# **Rohr Office Complex Final Environmental Impact Report (EIR # 90-10)**

SCH # 90010623

*Prepared by:*  
**Keller Environmental Associates, Inc. (KEA)**  
1727 Fifth Avenue  
San Diego, CA 92101

February 1991

Figure 2-2

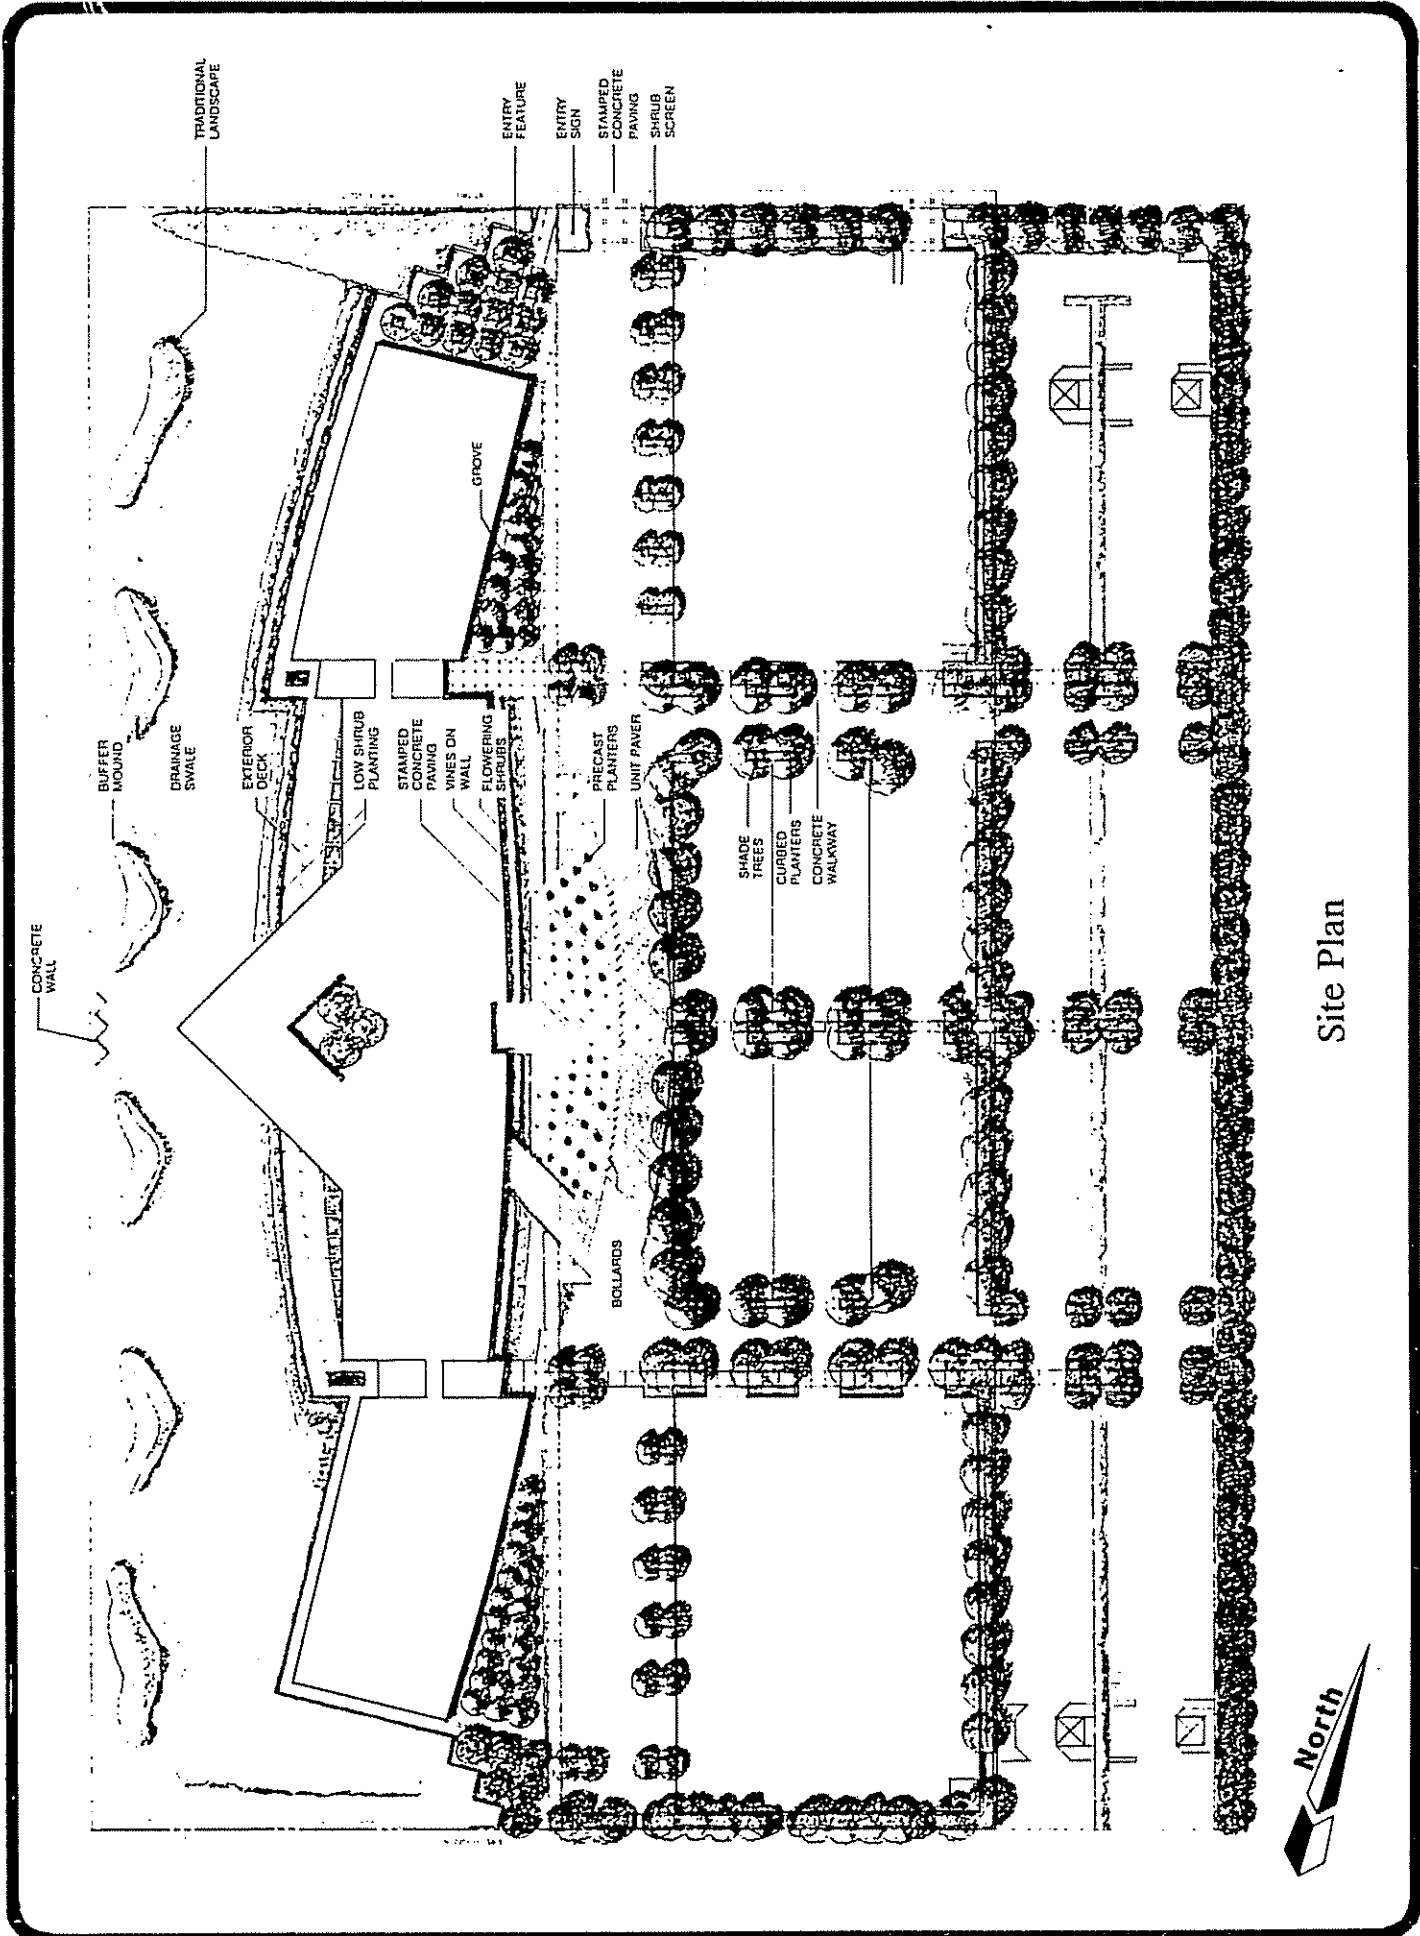
- G2 2. Page 2-4. Reference was made to Figure 2-3; however the figure is missing.
- G3 3. It seems that this project will create significant changes to existing traffic patterns, especially in the section of Bay Boulevard between "E" and "F" Streets and at the intersection of Bay Boulevard and "F" Street. The existing ADT 4160 on "F" Street will be increased by 2450 to 6110 ADT.

- G2 Mr. Nuhaily confirmed addressal of this comment.
- G3 As shown on Table 3-4 of the EIR, the existing ADT on "F" Street will be increased to approximately 5100 ADT between Tidelands Avenue and Bay Boulevard, and to 5900 between Bay Boulevard and Woodlawn Avenue.

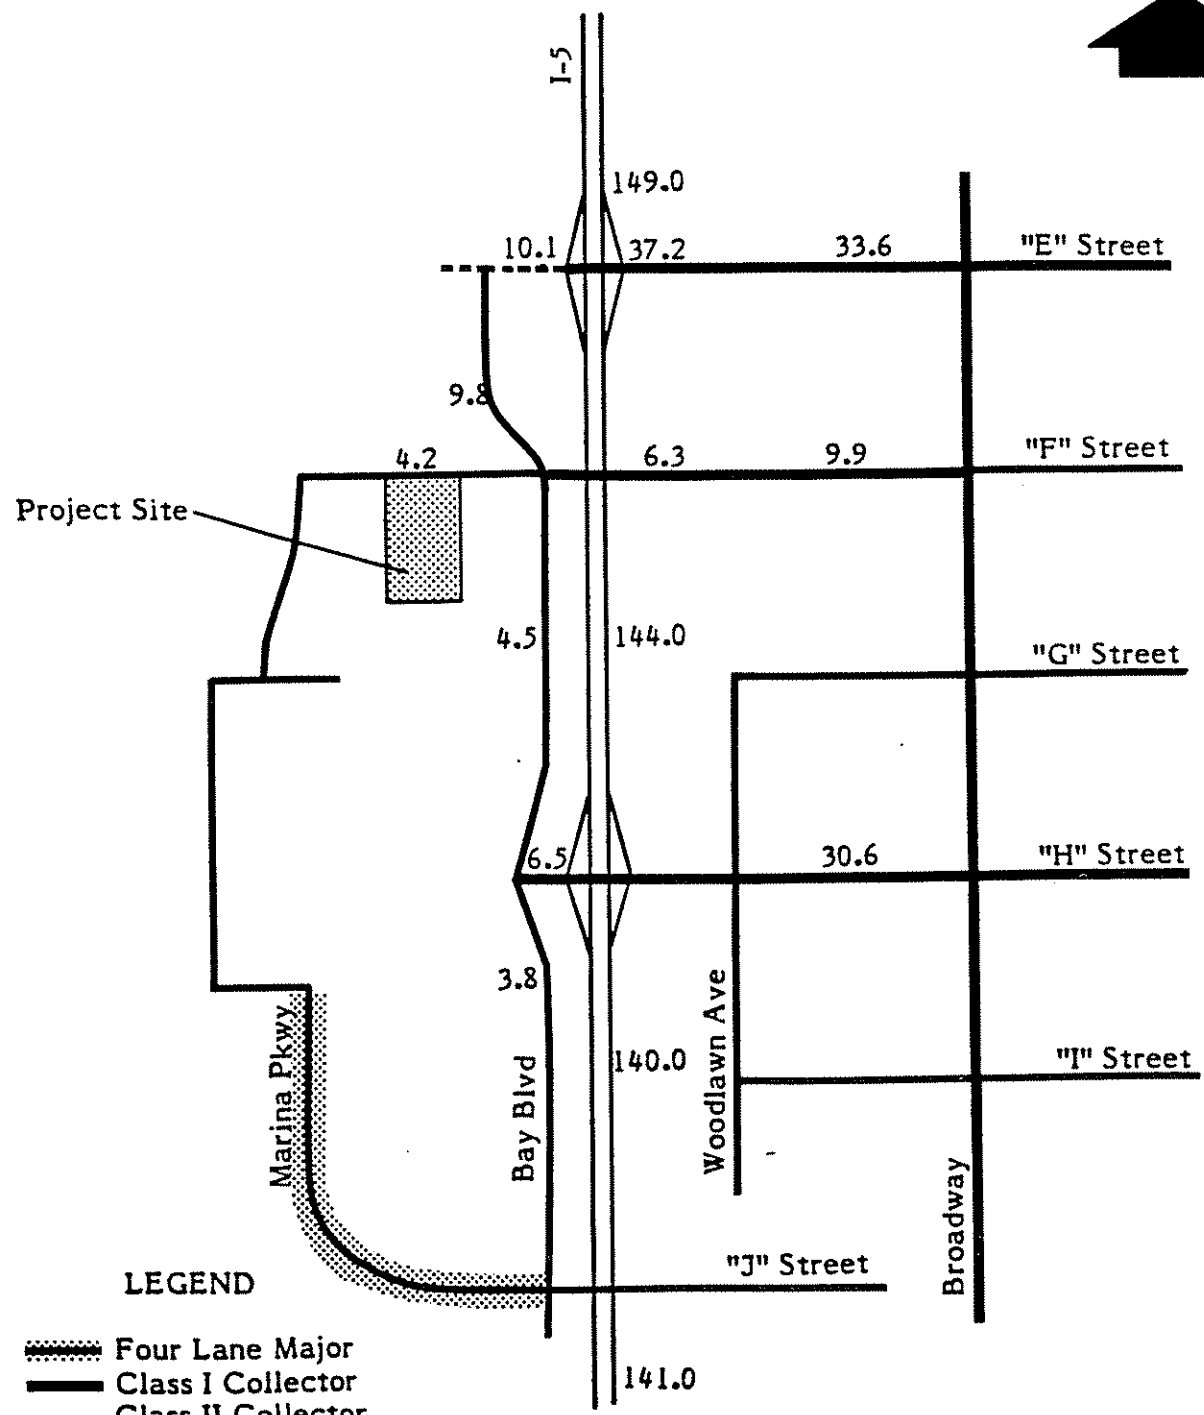
I17 Figure 3-9. Why isn't the Bay Blvd stretch between "E" and "F" included?

- I17 Acknowledged. The segment of Bay Boulevard between "E" Street and "F" Street was inadvertently omitted from this figure. However, the daily traffic volume on this segment is correctly labelled as 9,800.
